Product Change Notification

Product Change Notification: P-22-023825

General Product Description:
MULTIGIG RT2 and RT2-R Daughter connectors

TE MULTIGIG shroud, full size.

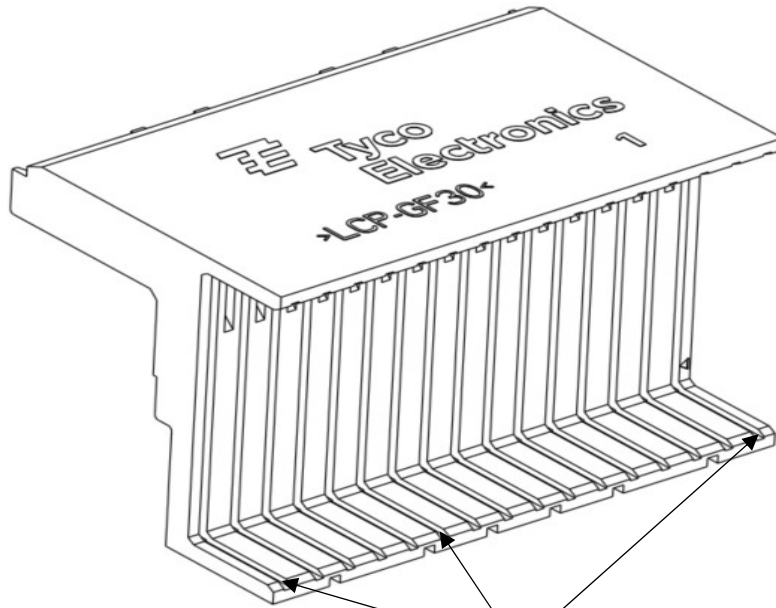
Increase the width of the wafer slots on housing (Shroud) by 0.09mm. See the images below.

Typical width of the wafer slots

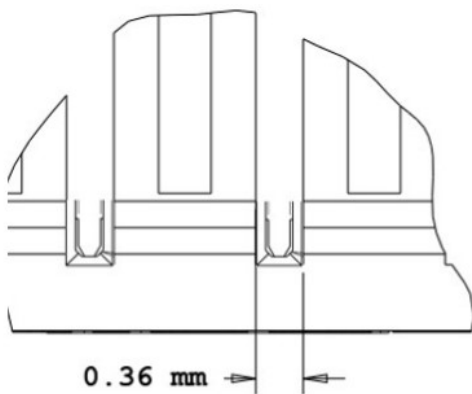
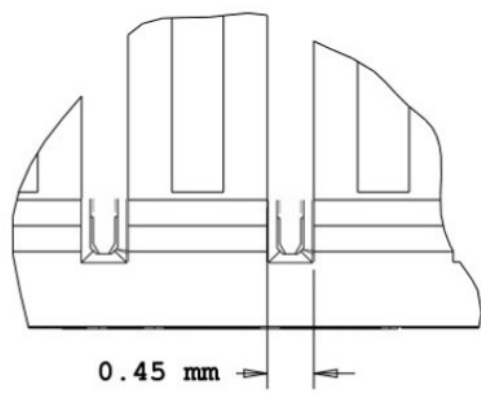
Description of Changes
Increase the width of the wafer slots on the housing(Shroud) by 0.09mm in order to reduce the risk of FOD (Foreign Object Debris) that can be generated by insertion of the PWB wafers during parts assembly
Other attachments:
[MULTIGIG Shroud Full size](#)
